PLAN COMMISSION STAFF REPORT

Agenda Item: PC 25-017

Application Type: Development Plan

Summary: Matt Kimmel is requesting consideration of a Development Plan for a single story,

Proposed SITE PLAN:

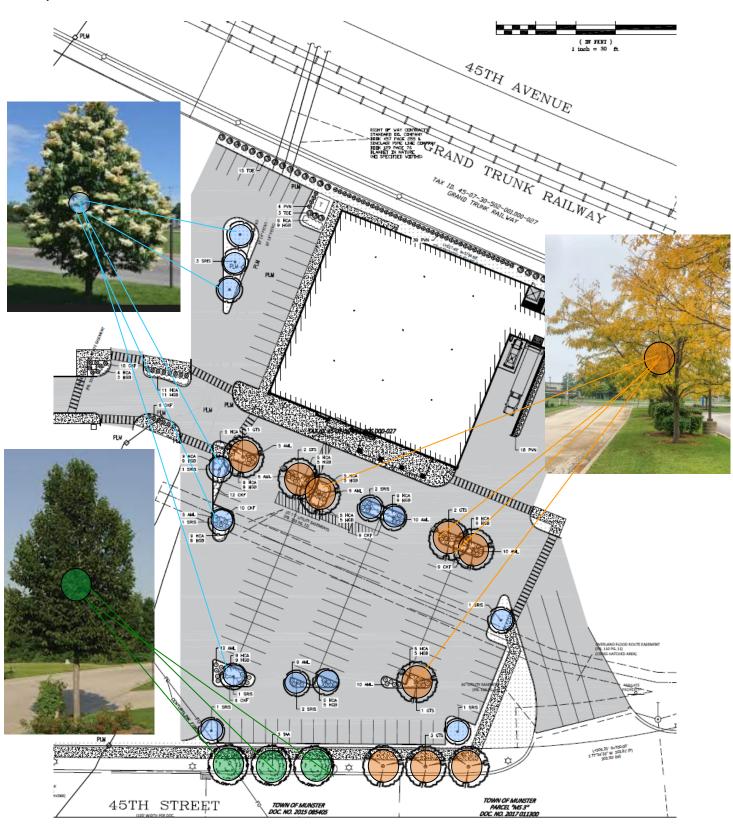
The applicant has secured a use for Lot C of Centennial Village. The proposed use is a single-story, 24,000 square foot Sprouts Market Grocery Store. The project will require a replat/subdivision, amendment to the PUD and a final determination will need to be presented for the proposed intersection of 45th Street and Centennial Drive. Impacts the site plan presented include change in parking counts and landscape. Current proposed site plan proposed include:

- Vehicle Parking = Required 76 Spaces (3.25 per GSF); Provided 127 including 5 ADA.
- Bicycle Parking = not identified
- Trees/Evergreens/Ornamentals = 25
- Building Materials = Brick, per PUD
- Lighting = Decorative per PUD
- Traffic = engineer's review of traffic impact report needed.
- Stormwater = Connection to existing development management system
- Subdivision/Replat of Lot C to create proposed Lot 10 for Sprouts Market (PC 25-015)
- Amendment to the Centennial Village PUD (PC 25-016)

Motion to DEFER PC 25-017, a proposed Sprouts Market Grocery Store to November 14, 2025 to allow the applicant to submit payment of the Development Plan Application and present a development plan reflecting the intersection improvement of 45^{th} Street and Centennial Drive., including all discussion and findings.
